Project Name	30 Fairlight St, Fairlight	Project Number	00012781
Project Address	30 Fairlight St, Fairlight, NSW 2094	Drawing Name	Basement Plan
		Scale	1:150, 1:1 (A3)
		Date	August 2023
Client	Adjani Pty Ltd	Drawing Number	DA200
		Revision	I

**MOD2023/0479**

**SCHEDULE OF CHANGES**

PROJECT  
Residential Development  
30 Fairlight street,  
FAIRLIGHT, NSW

DRAWING TITLE  
LANDSCAPE PLAN  
- SOIL DEPTHS

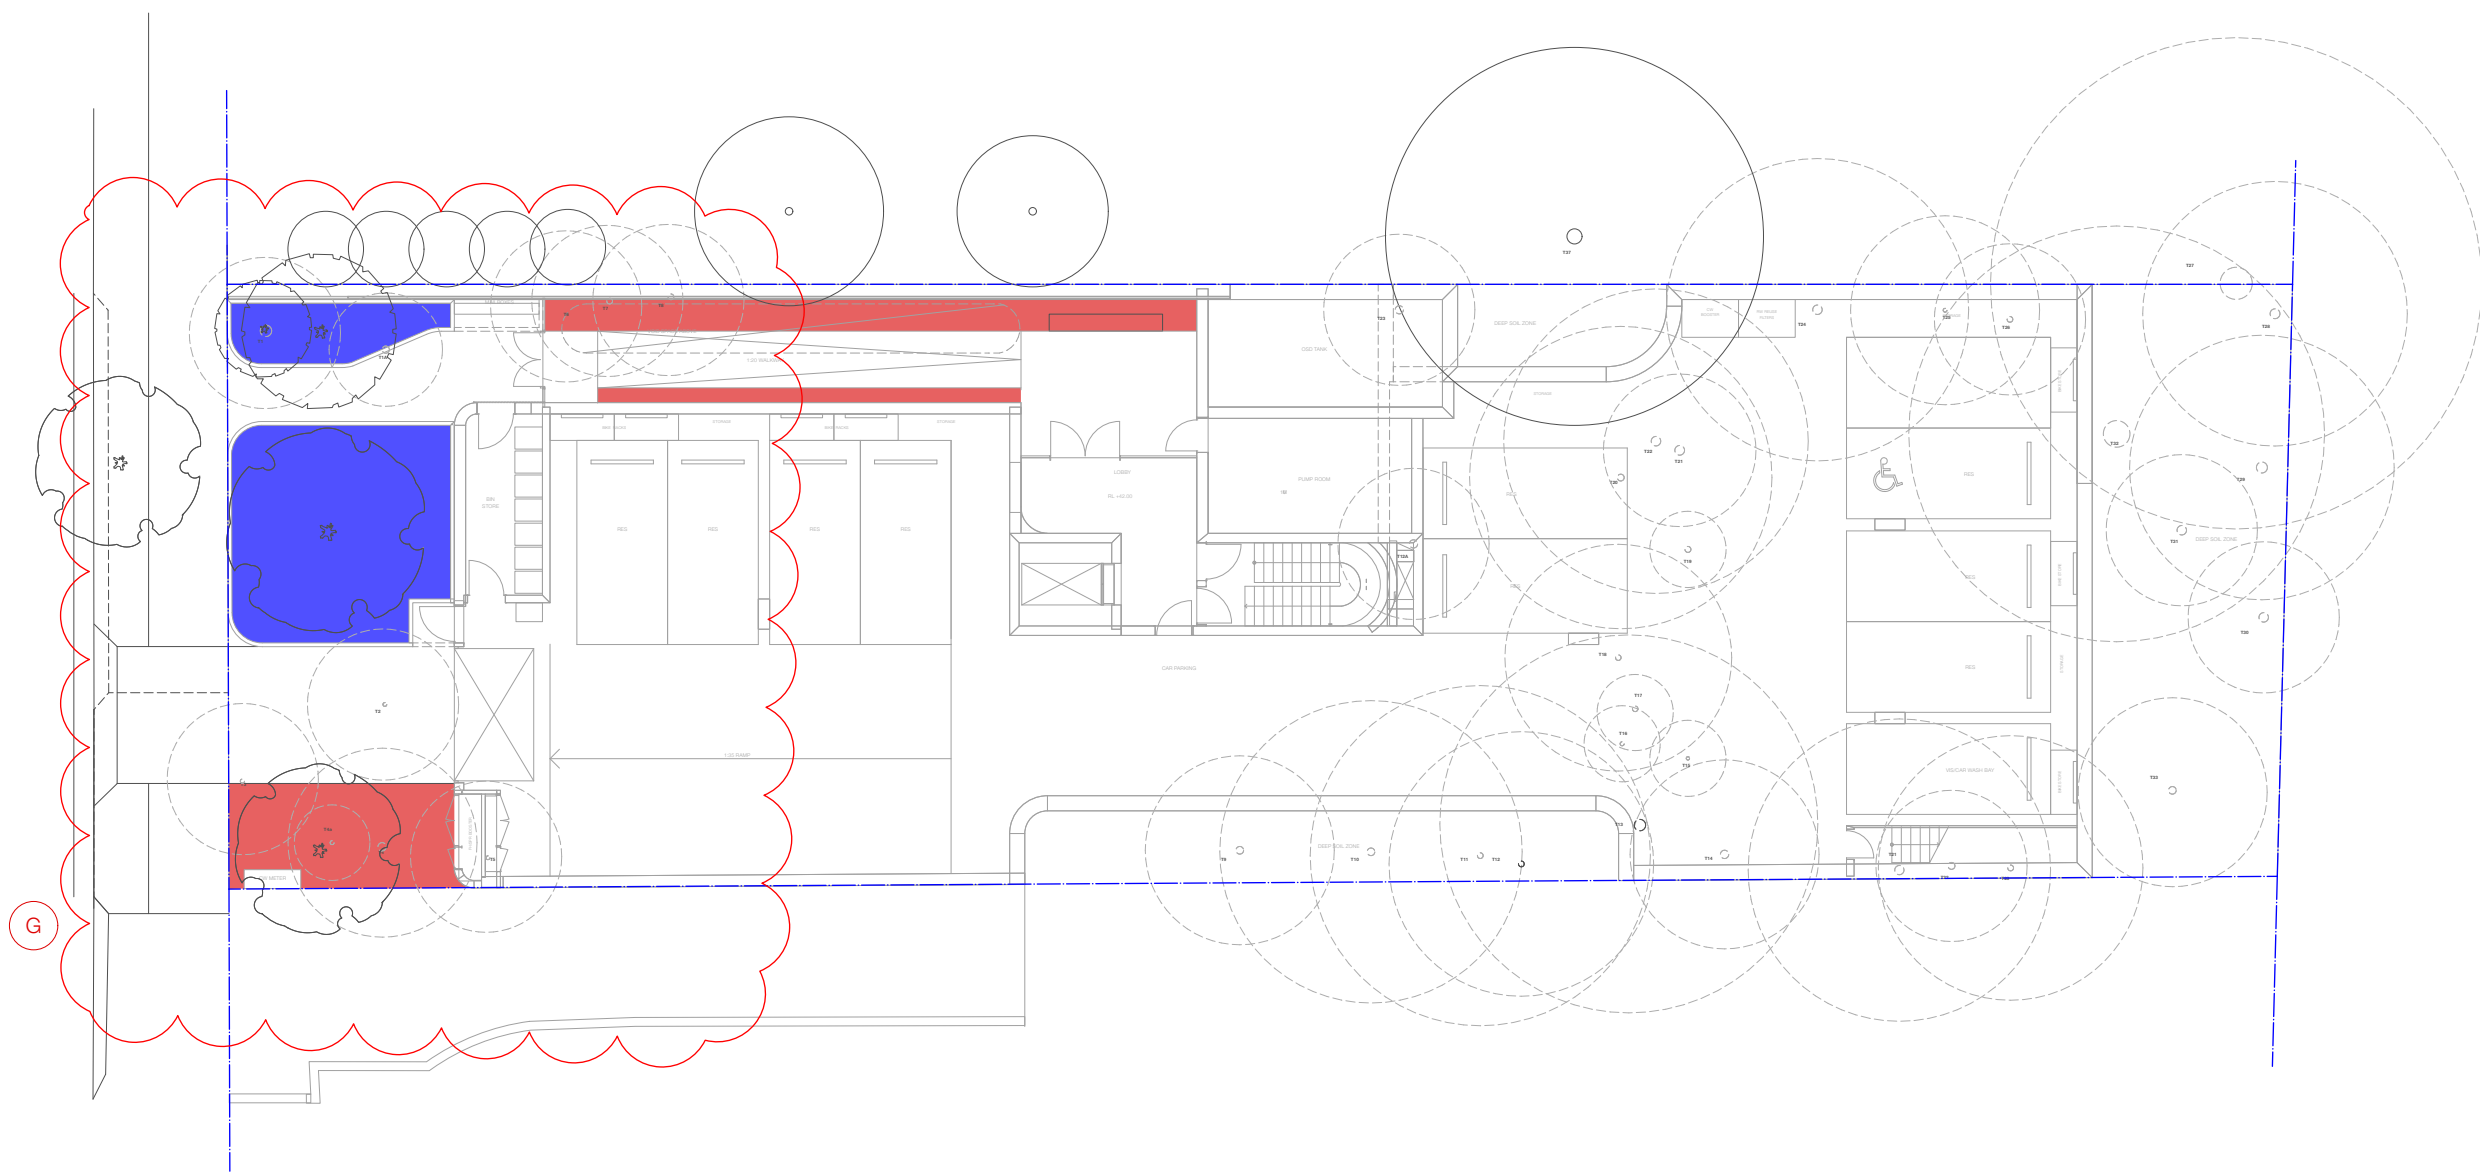
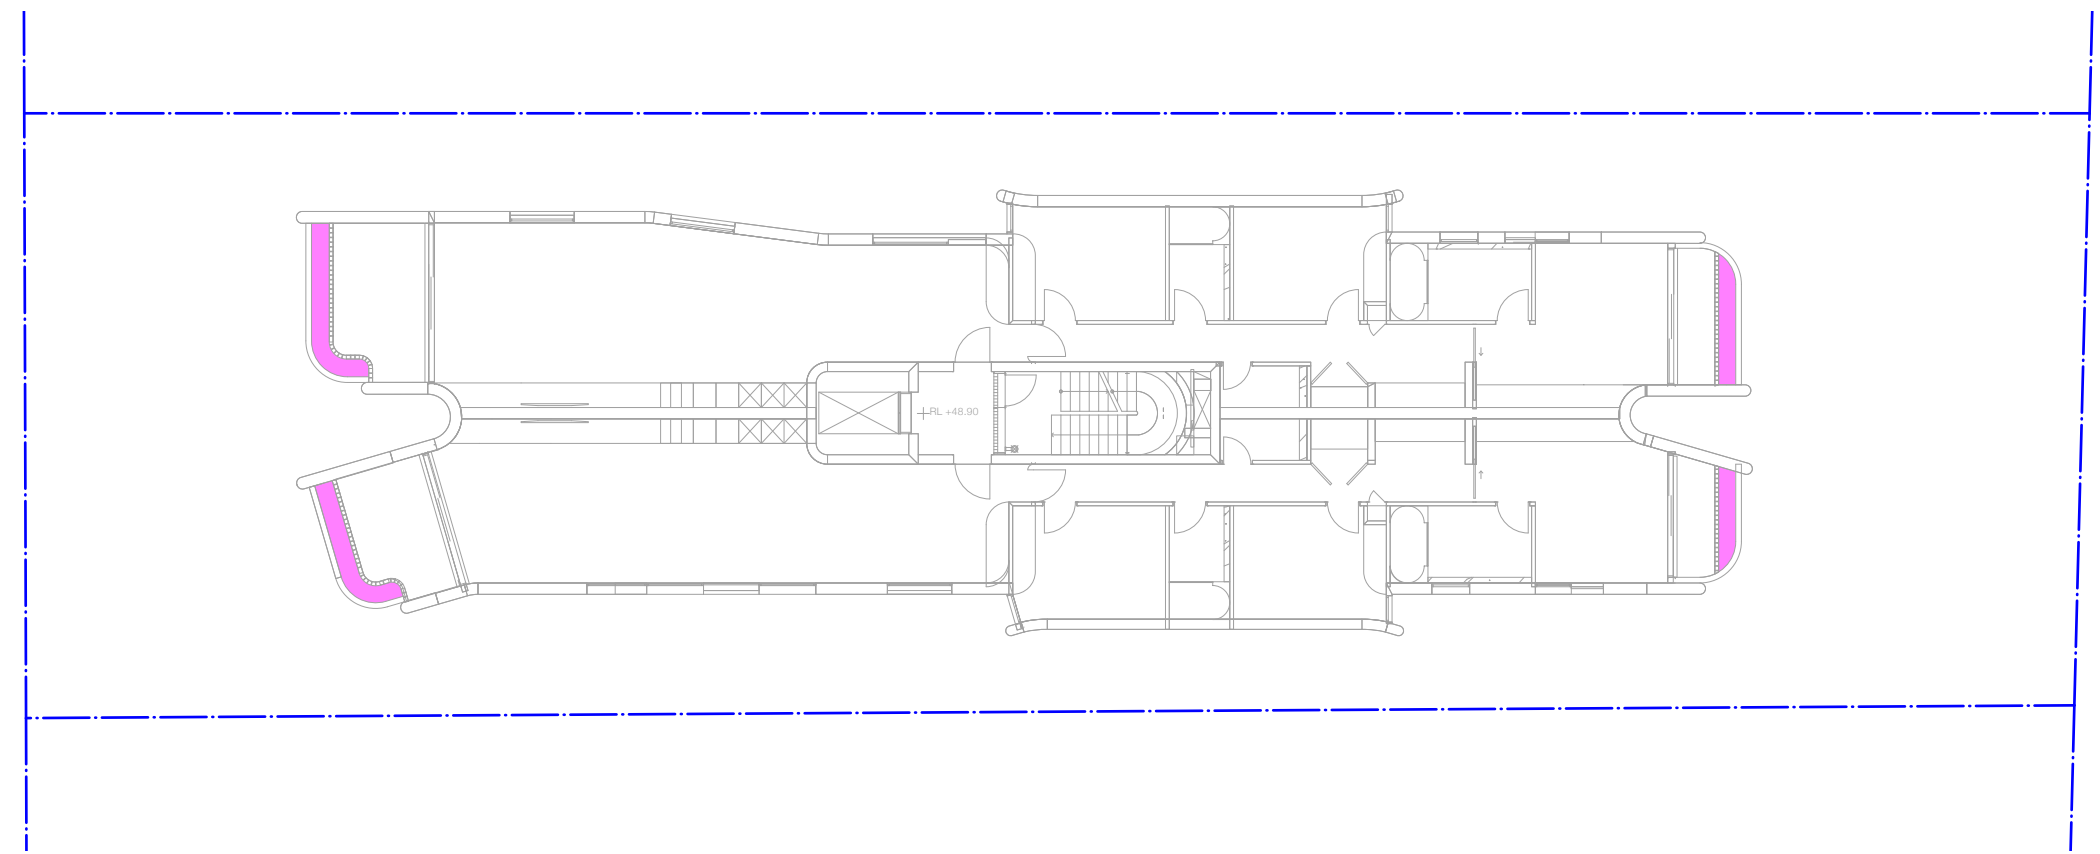
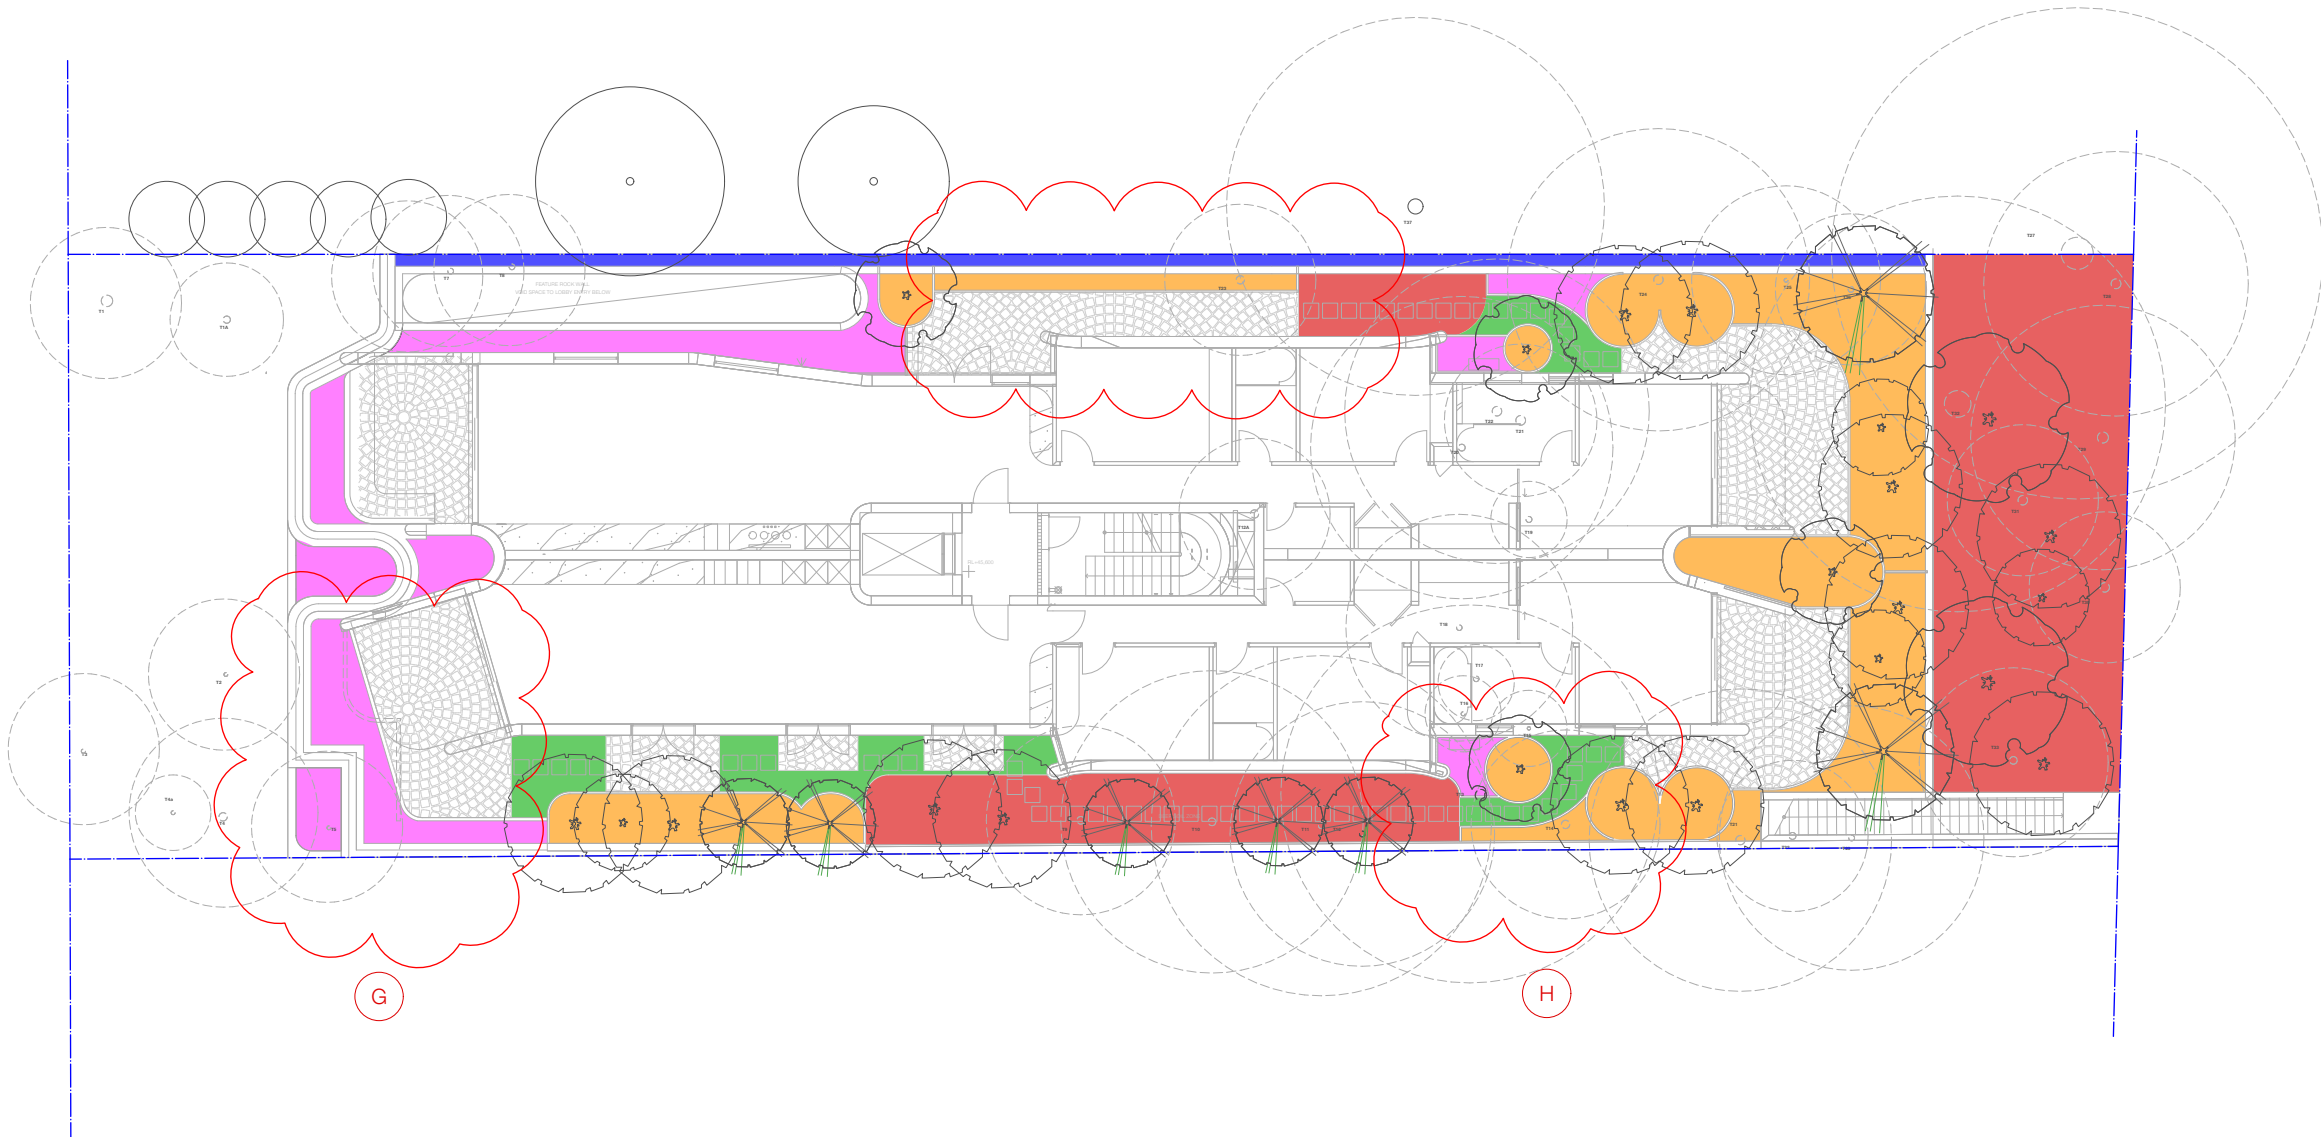
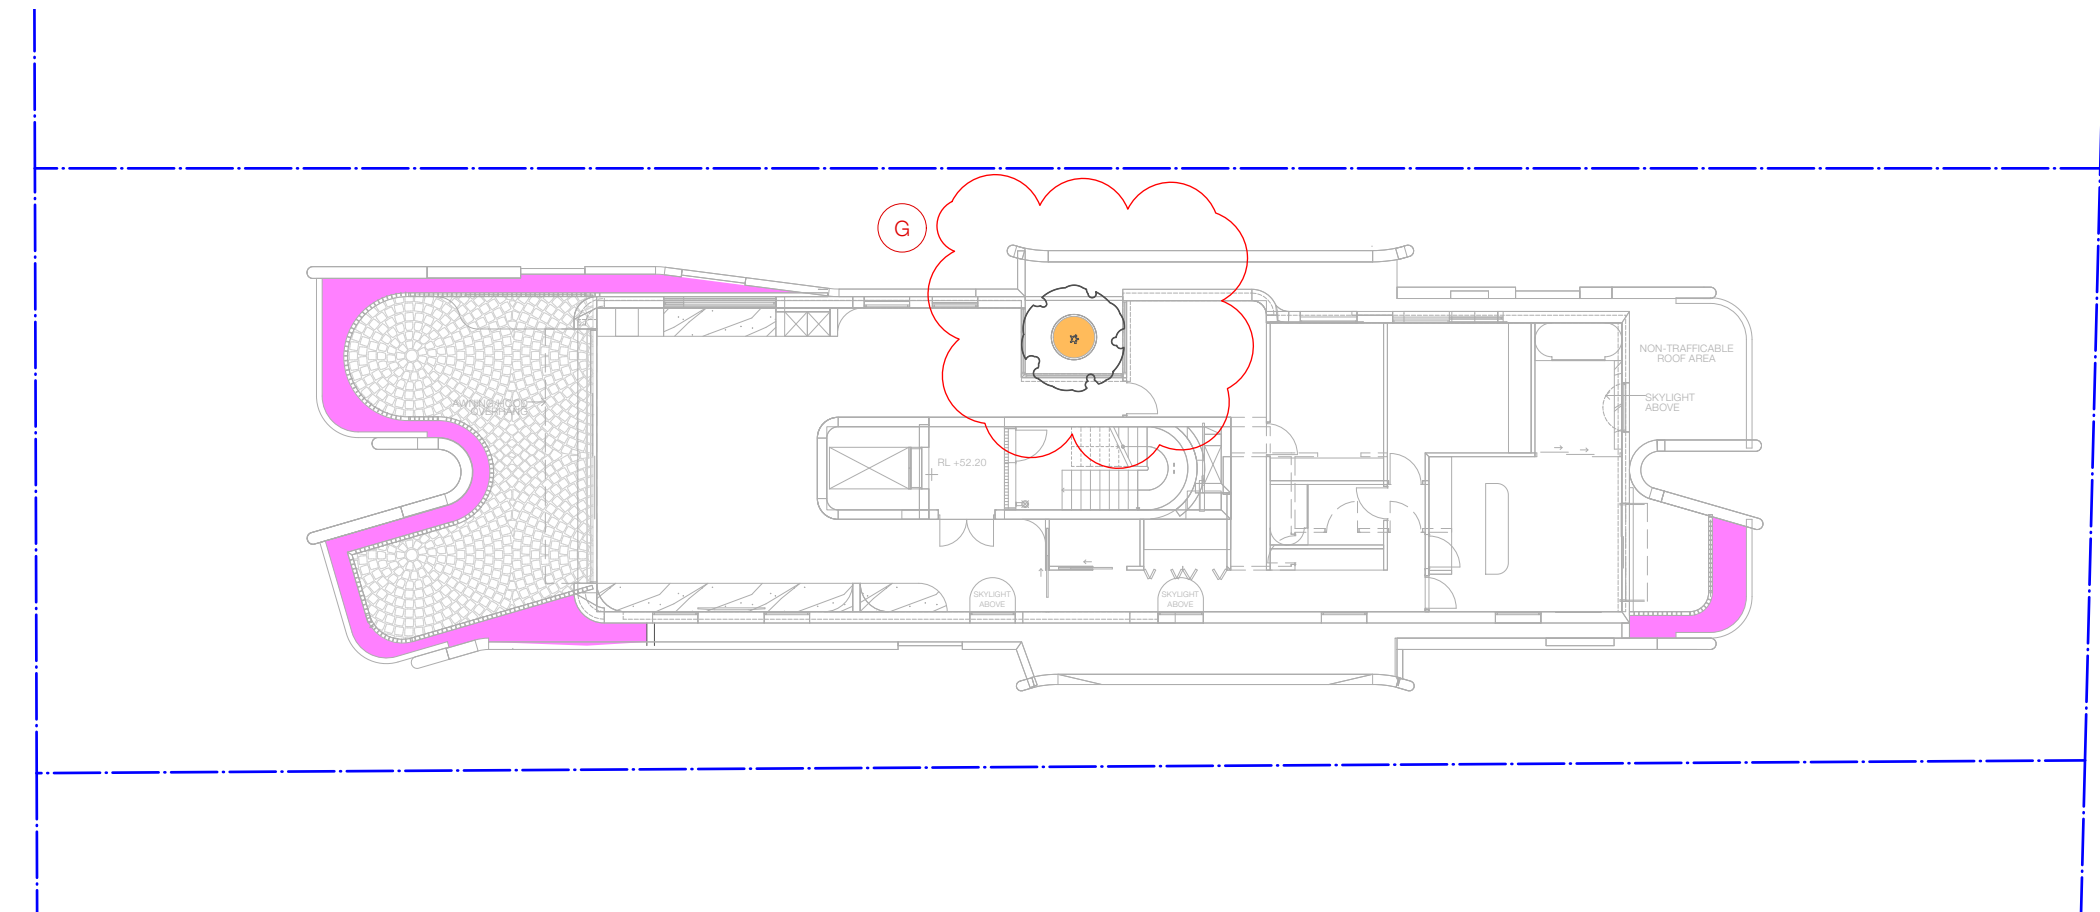
- AMENDMENTS
- A. PLANTER AND DEEPSOIL REDUCED TO ACCOMMODATE RELOCATION OF MAILBOX FOR DDA COMPLIANCE.
- B. ADDITIONAL DOOR ADDED AND DEEP SOIL REDUCED TO ALLOW FOR COMPLIANCE AS ALTERNATE FIRE EGRESS WITH NCC D2D6
- C. REVISED LANDSCAPING ARRANGEMENT TO ACCOMMODATE RELOCATED CW METER
- D. OSD TANK EXTENDED TO ACCOMMODATE MINIMUM VOLUME AS PER STORMWATER ENGINEER'S REPORT.
- E. WALL OF FRONT TERRACE RATIONALISED FOR BUILDABILITY - REVISED LANDSCAPE
- F. COURTYARD LANDSCAPE AMENDMENT. REVISED LANDSCAPE EXTENT
- G. REVISED LANDSCAPE AREAS
- H. REVISED SOIL DEPTH
